3.4 Instrumentation and Control

The information in this section of the reference ABWR DCD, including all subsections, tables, and figures, is incorporated by reference with the following departure.

STD DEP T1 3.4-1 (Figure 3.4a, Figure 3.4b, Figure 3.4c)

Figure 3.4a Safety System Logic and Control (SSLC) ~~Control~~ Interface Diagram

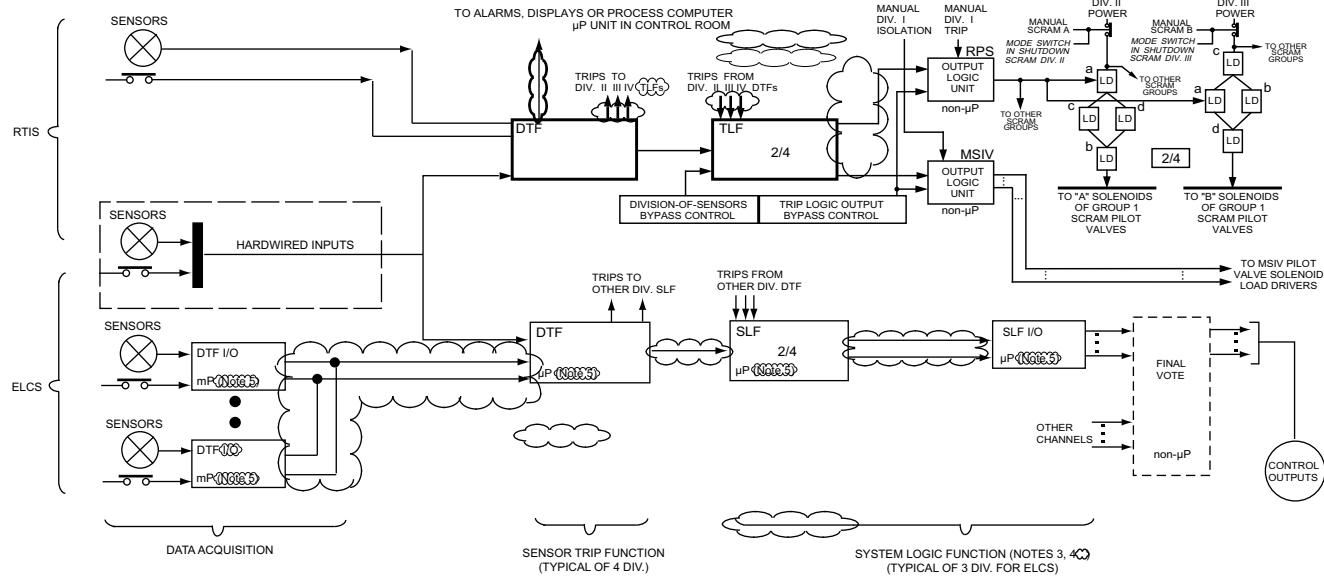
safety-related portions of the Neutron Monitoring System (NMS), the Containment Atmospheric Monitoring System (CAMS) and the radiation monitoring systems. The relationship between SSLC and systems for plant protection is shown in Figure 3.4a.

Figure 3.4b Safety System Logic & Control Block Diagram

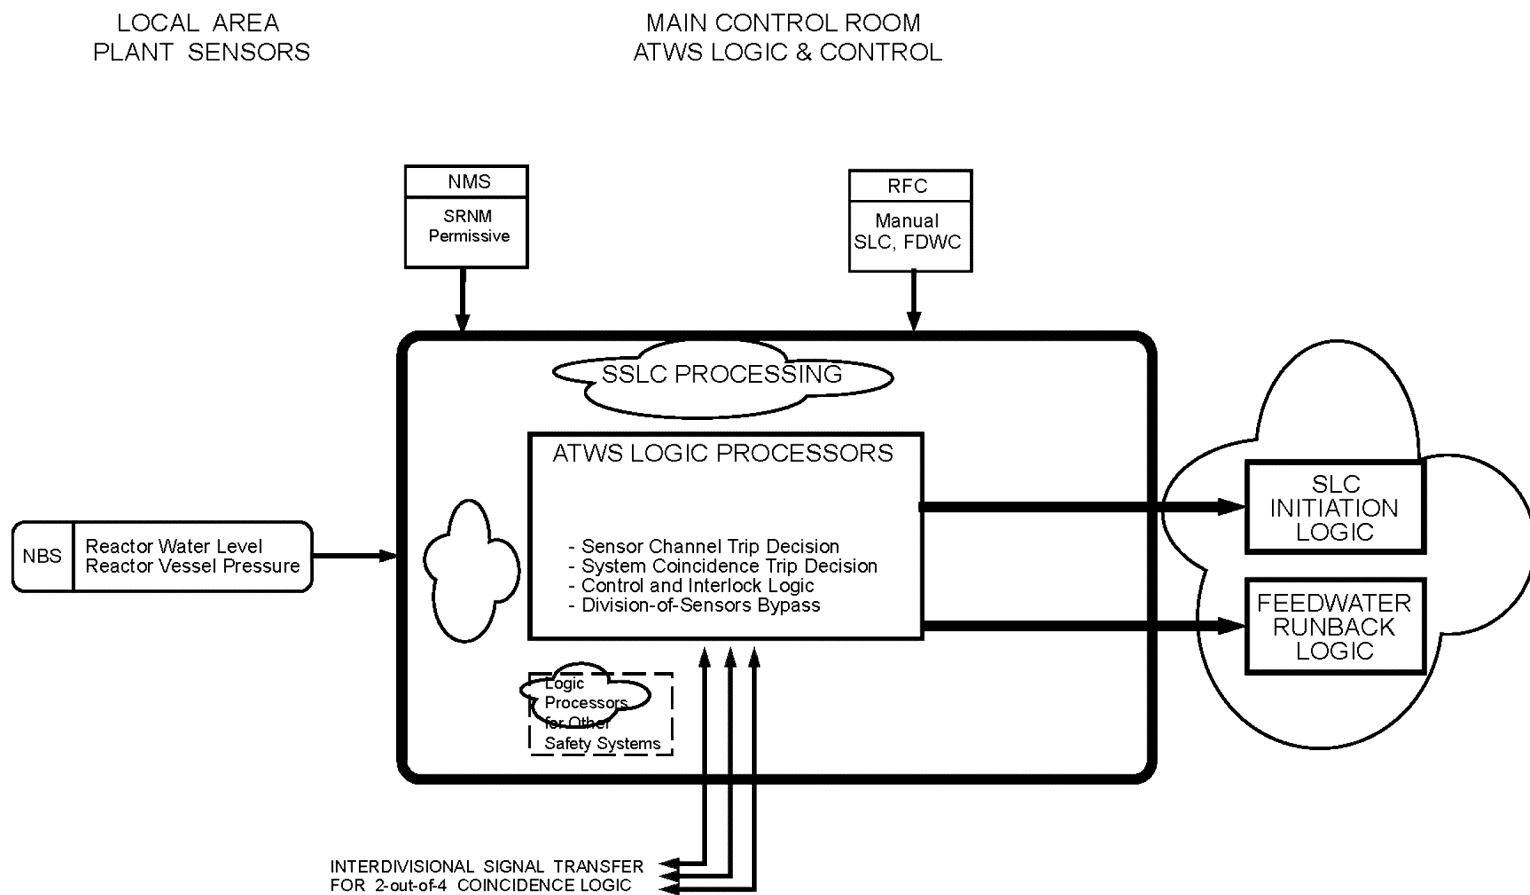
~~The basic hardware functional~~ configuration for one division of SSLC is shown in Figure 3.4b. Each division runs independently (i.e., asynchronously) with respect to the other divisions. The following steps describe the processing sequence and associated function descriptions for incoming sensor signals and outgoing control signals. These steps are performed simultaneously and independently in each of the four divisions:
